MINOR ELEVATIONAL NON MATERIAL AMENDMENTS (AUGUST 2022)

AUGUST 2022 MINOR NON MATERIAL AMENDMENTS TO MCC PLANNING PERMISSION (REF. 132391/FH/2021)

Scheme
Loft Conversion Works
466 Parris Wood Road
Didsbury
Manchester M20 5QQ
Client

Mr & Mrs Tennant
Title
Proposed Elevations

REAR ELEVATION
Proposed

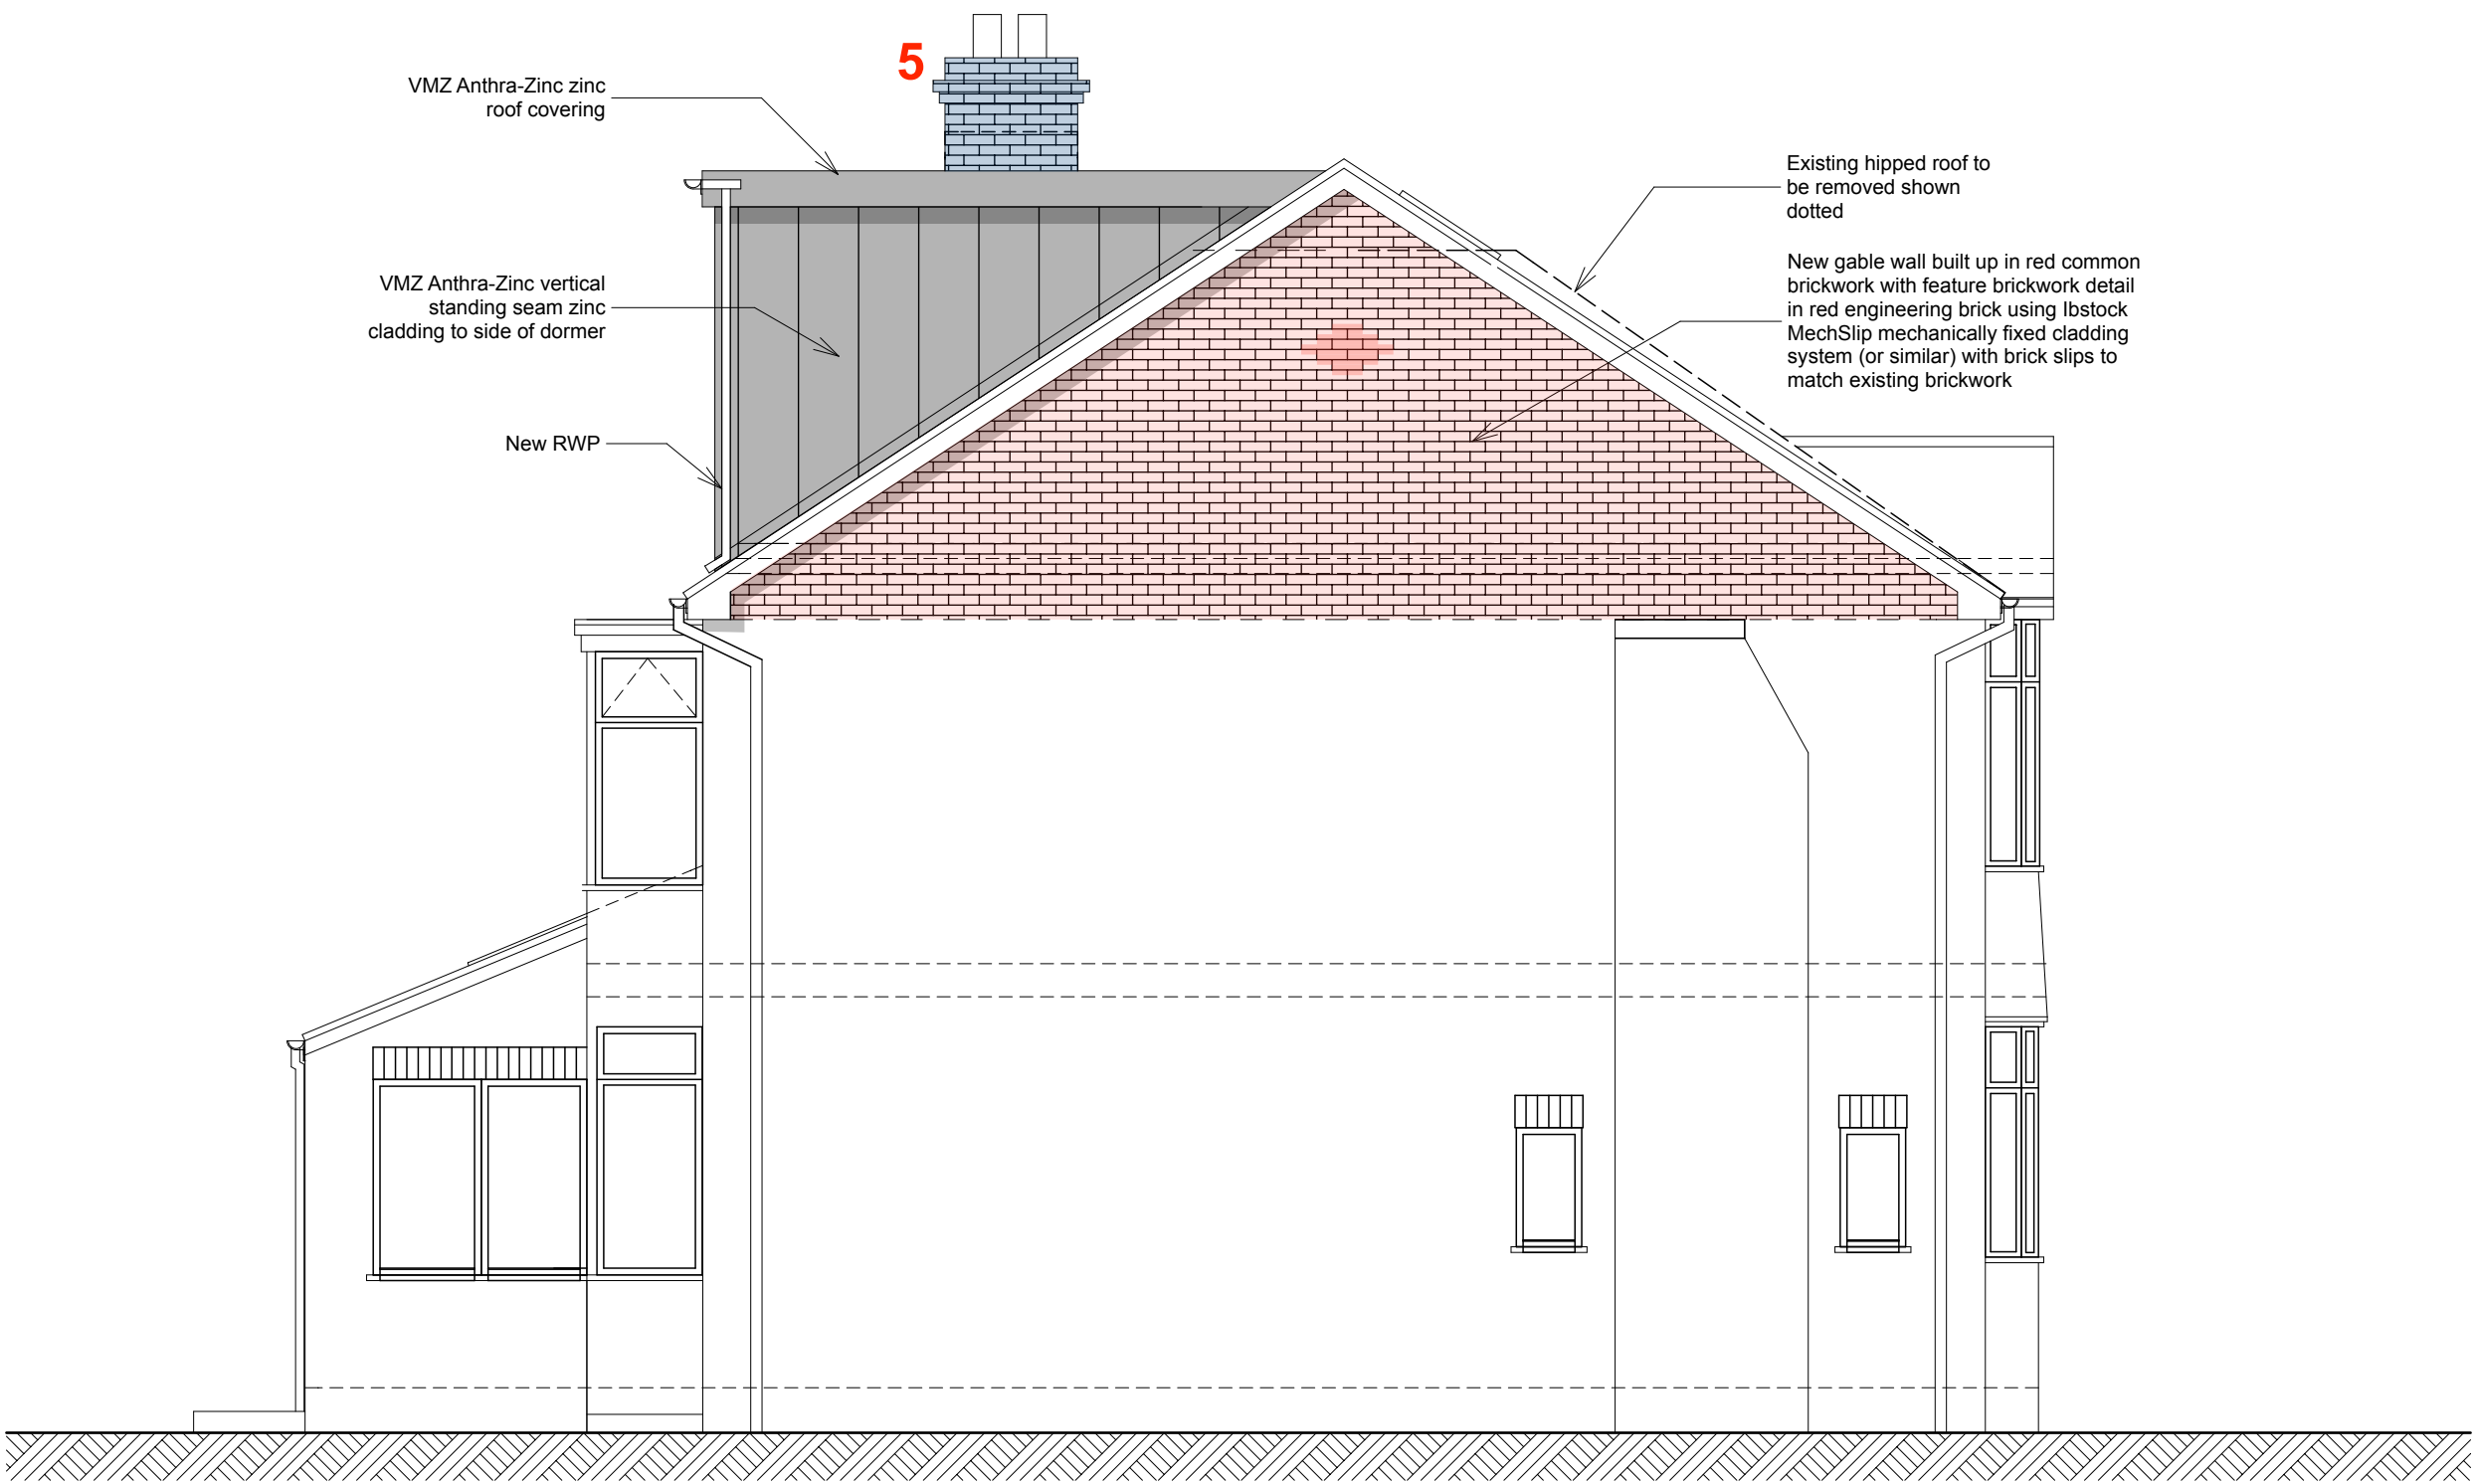
1. SOLAR PANELS OMITTED TO FRONT ELEVATION ROOF
2. 2NO. VELUX WINDOWS OMITTED TO FRONT ELEVATION ROOF
3. SLIDING FOLDING DOORS PROVIDED TO SECOND FLOOR REAR ELEVATION IN LIEU OF GLAZED SCREEN/DOOR
4. CEDRAL CLADDING ON DORMER LOFT REAR ELEVATION AMENDED FROM DARK OAK TO CREAM WHITE (C07) COLOUR
5. EXISTING CHIMNEY BUILT UP IN BLUE ENGINEERING BRICKWORK 0.75m ABOVE NEW DORMER LOFT ROOF
